ADDENDUM #2
NWIT-15-34
Anvil Centre Interior Alterations
Anvil Centre, New Westminster, BC

ADDENDUM NO. 1

PROJECT TITLE:
**ANVIL CENTRE
RENOVATIONS**

PROJECT NO. 105B-007-15
DRAWING NO. M-AD-1.1

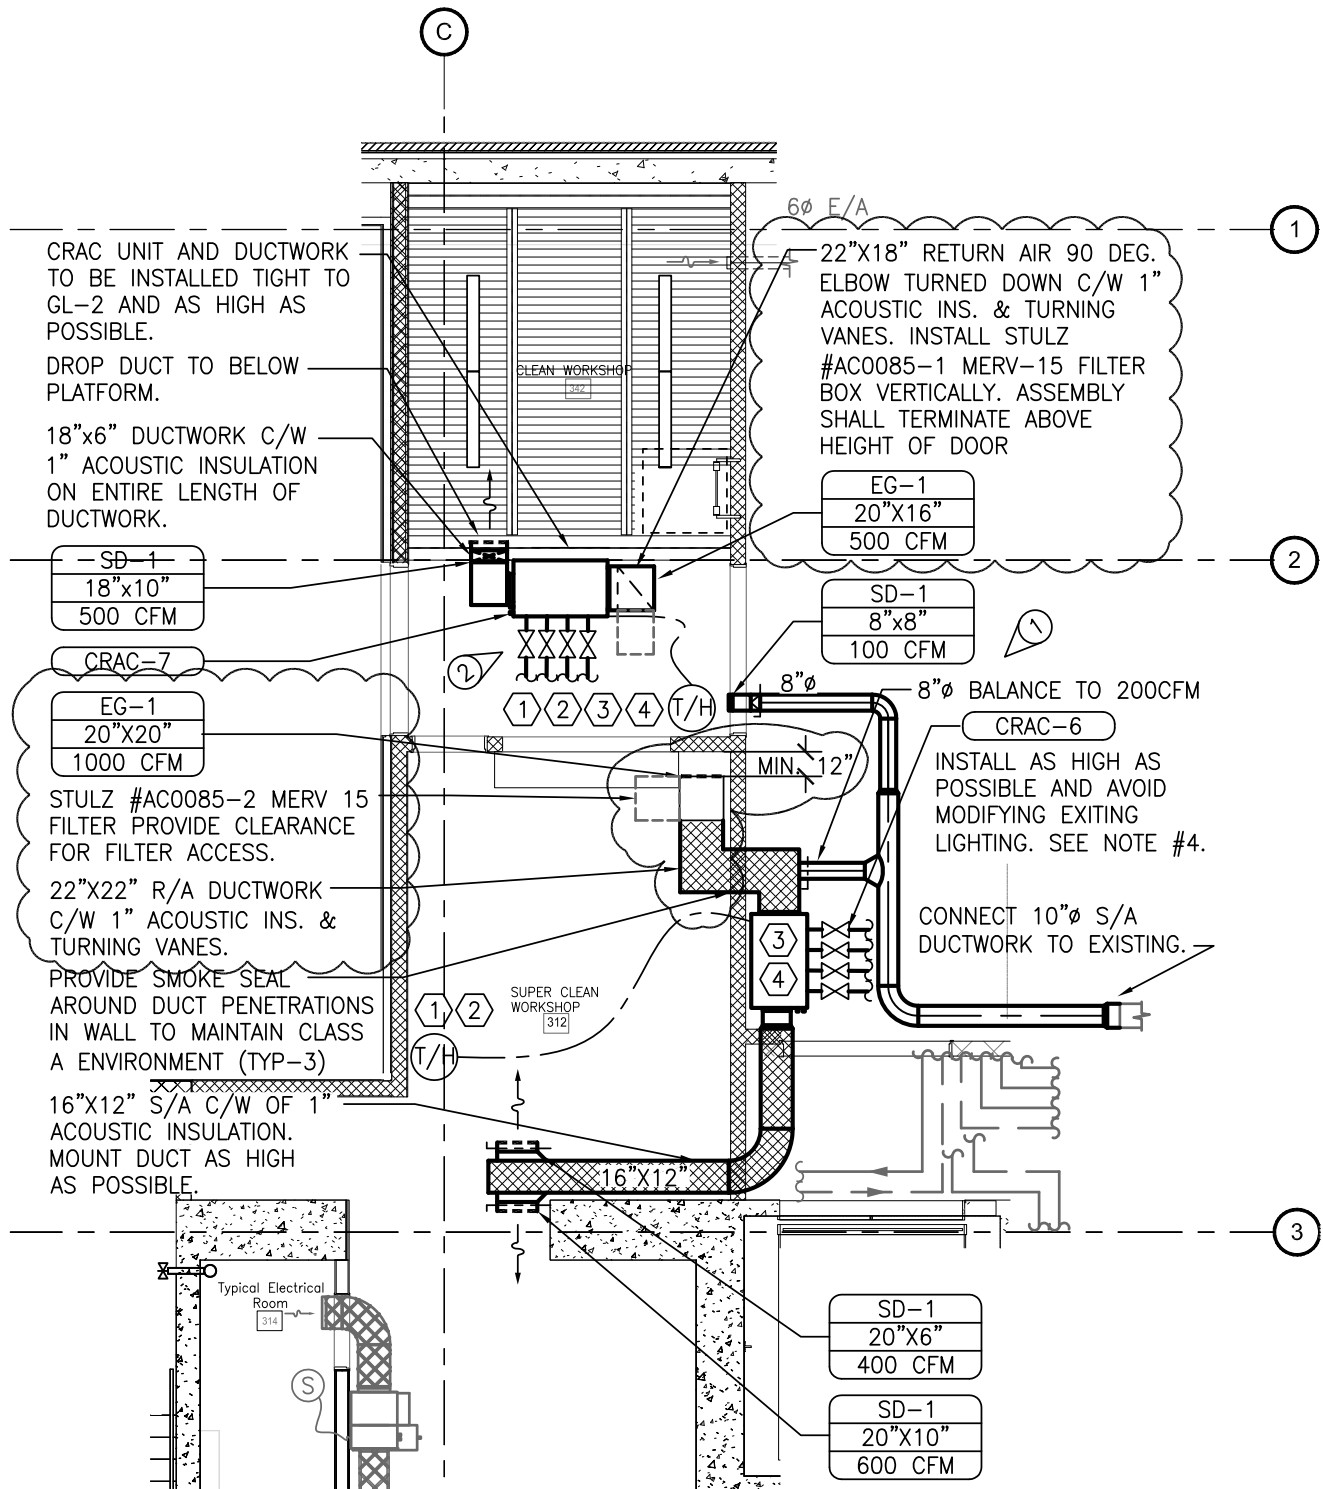
REVISE: CRAC-7 return air duct size to 22" x 18", and revise filter to Stultz #AC-0085-1 Merv 15 filter box. The contractor shall provide a 90 degree elbow, duct towards the floor, and c/w 1" acoustic insulation & turning vanes. Install the Stultz filter box vertically in-line with return air ductwork.

Return air duct and Stultz filter box configuration shall terminate at door height of door to avoid clash between door and filter box.

REVISE: CRAC-6 return air duct layout and size to 22" X22" c/w 1" acoustic insulation and turning vanes. Revise filter to Stultz #AC-0085-2 Merv 15 filter. Filter box shall be installed in-line with return air ductwork.

Refer to the attached sketch M-AD-1.1 for details.

1 CRAC UNIT SCHEMATICS
 M1.02 SCALE: NOT TO SCALE

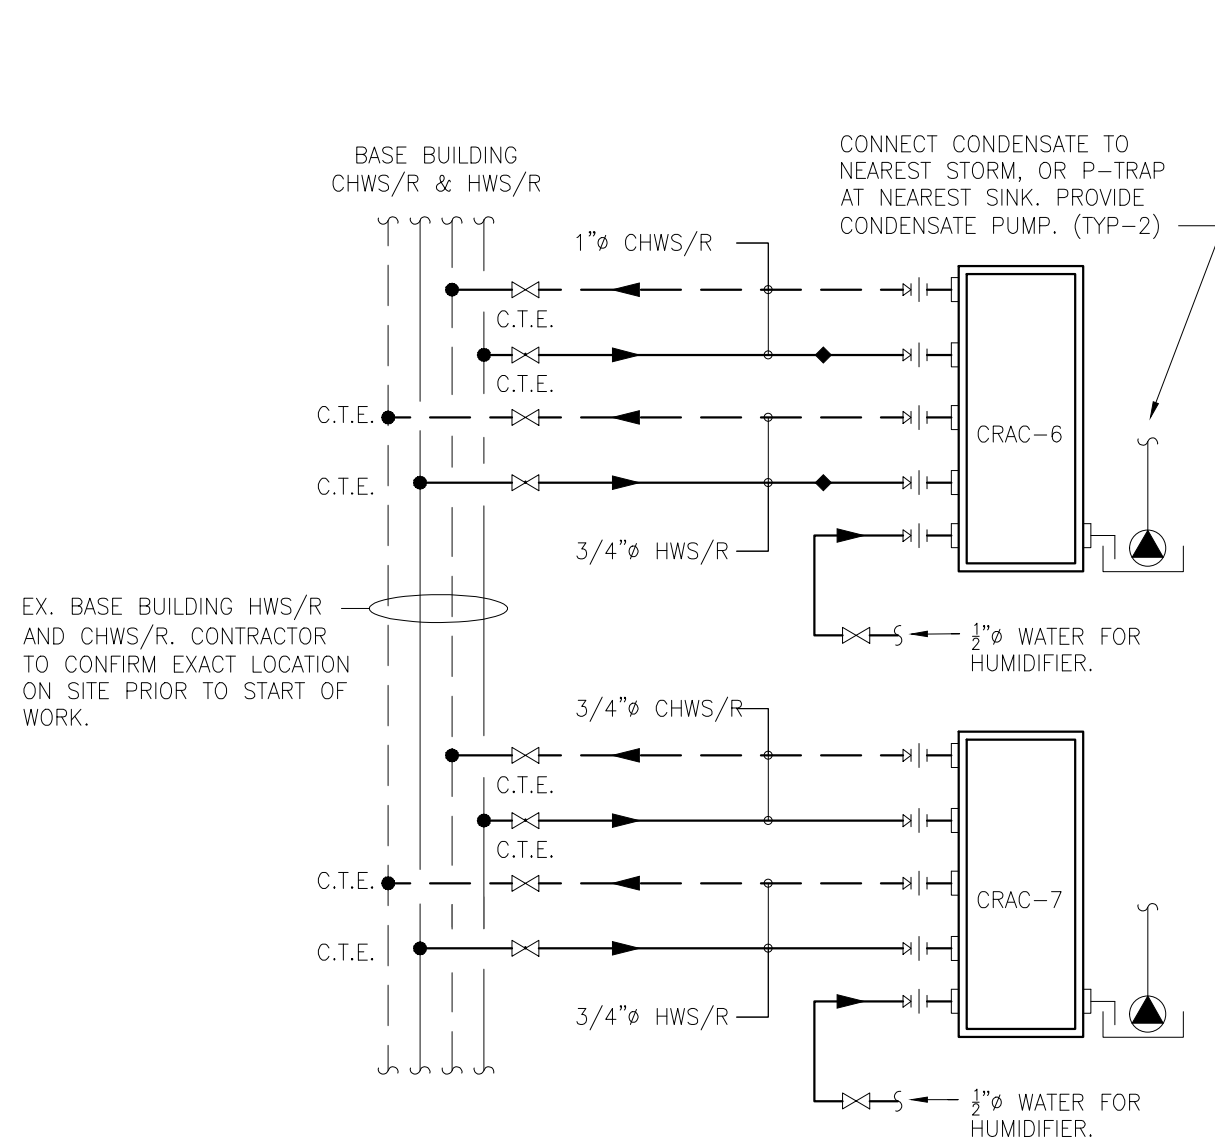
ADD: Drawing M1.02 which identifies the location and routing of cold water connections to the humidifier's located in CRAC-6/7. Drawing M1.02 also provides a hydronic schematic for CRAC-6/7. See attached M1.02.
